Applicant: NICK PATEL KESHAV CORP. BUILDING
Request: PERMIT
Meeting Date: 1/24/2023 (rescheduled from 1/9/2023)

Address: 10320 Dutchtown Rd.
Map/Parcel Number: 118 17608
Location: East side of Dutchtown Rd south of its intersection with Cogdill Rd
Existing Zoning: C-H-1 (Highway Commercial) / F (Floodplain Overlay) / TO-1 (Technology Park Overlay)
Proposed Zoning: N/A
Existing Land Use: Vacant land
Proposed Land Use: Commercial development consisting of a gas station, convenience store, and strip center
Appx. Size of Tract: 2.75 acres
Accessibility: Access will be off of Dutchtown Road, a minor arterial with a 60-ft pavement width inside a right-of-way that varies in width.
Surrounding Zoning and Land Uses:
 North: C-H-1 (Highway Commercial) / TO-1 (Technology Park Overlay) in the City - vacant land (though an indoor/outdoor self-storage facility was recently approved (TTCDA Cases 4-B-22-TOB & 10-A-22-TOA))
 South: BP (Business and Technology Park) / TO (Technology Overlay) in Knox County - Single family detached residence

**1-A-23-TOB
CERTIFICATE OF APPROPRIATENESS**

DUTCHTOWN RETAIL CENTER

C-100

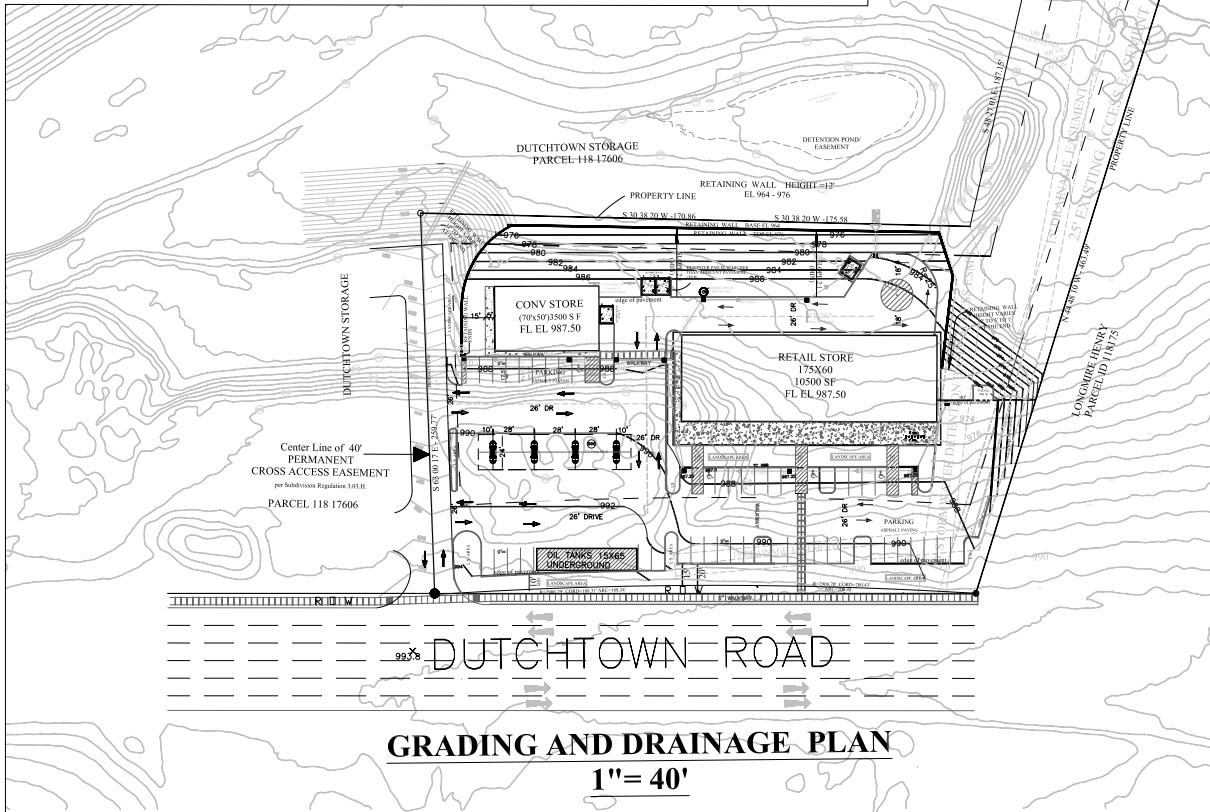
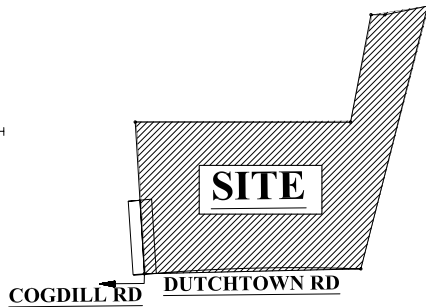
13) A parking lot setback of 20 feet is required when there is parking between the right-of-way and a proposed building. The applicant has requested a waiver to reduce the parking lot setback to 10 feet. If this board wishes to approve the plans as drawn, a waiver would be needed to reduce the parking lot setback to 8 feet in front of the convenience store and 15 feet in front of the retail strip center.

a. Staff does not find the criteria for a waiver as defined in the TTCDA Guidelines has been met, so staff cannot support approval of this waiver. The Guidelines state that a waiver can be issued when strict application of the Guidelines is not feasible and when public health, safety, and welfare would not be adversely affected.

i. A 20-ft parking lot setback would reduce parking and maneuvering space for the fuel truck while delivering fuel to tanks. Ideally, site plans are designed around building and parking lot setbacks from the onset, so parking and space to maneuver should be applied to the design within those parameters.

ii. It may cause traffic backup for vehicles visiting the retail center since the area in question is near the only entrance. However, the drive aisles and entry are required to be 26 ft, which is what is proposed. Therefore, these areas could not be reduced in size, thereby reducing maneuverability. If the parking lot setback were made wider, the whole plan would have to shift, and maneuverability would not be affected.

iii. Moving the site plan components toward the rear of the site would make the slope behind the building steeper, which may violate city regulations. This property is not in the HP (Hillside Protection Overlay) zone, so the City's HP zone regulations do not apply. The City does not have other regulations limiting the degree of slope in yard space where no structures or drive aisles are present. However, staff sees the value in preserving the natural slopes as much as possible, and for that reason could support a waiver to reduce the parking lot setback to 15 ft. The site plans could eliminate the 4 parking spaces in the northeast corner of the site (bottom left of the drawing) and provide a 15-ft parking lot setback with the landscaped buffer, and still be in compliance with minimum parking requirements without needing to shift the site plan back on the site.

I request a waiver from the design guidelines requiring a 20 feet buffer and setback from the right of way within the convenience store area only. a 20 feet setback would reduce parking and maneuvering space for the fuel truck while delivering the fuel to tanks. It may also cause the traffic back up for vehicles visiting the retail center, since this is the only entrance.

Current condition as shown per site plan is to deliver the fuel without blocking the driveway, and would be the best approach for the traffic safety and easy maneuvering.

Moving the entire concept toward the rear, will make the slope steeper and may violate the city regulations.

I have intended to keep 10 feet minimum from the beginning, 15 feet at the end of the convenience store, and will make sure it measures correctly.

1) Deny the waiver request to decrease the parking setback from 20 feet to 10 feet because Planning does not find the cited reasons meet the criteria for waiver approval as stated in the TTCDA Guidelines. Staff could support a waiver of 15 feet in front of the convenience store/gas station if this board decides to approve a lesser waiver.

- 5) Meeting all applicable requirements of the City of Knoxville Zoning Ordinance.
- 6) Revision of the site plan to eliminate the 4 spaces in the northeast corner of the site to accommodate a 15-ft parking setback area in front of the convenience store/gas station unless this board decides otherwise.
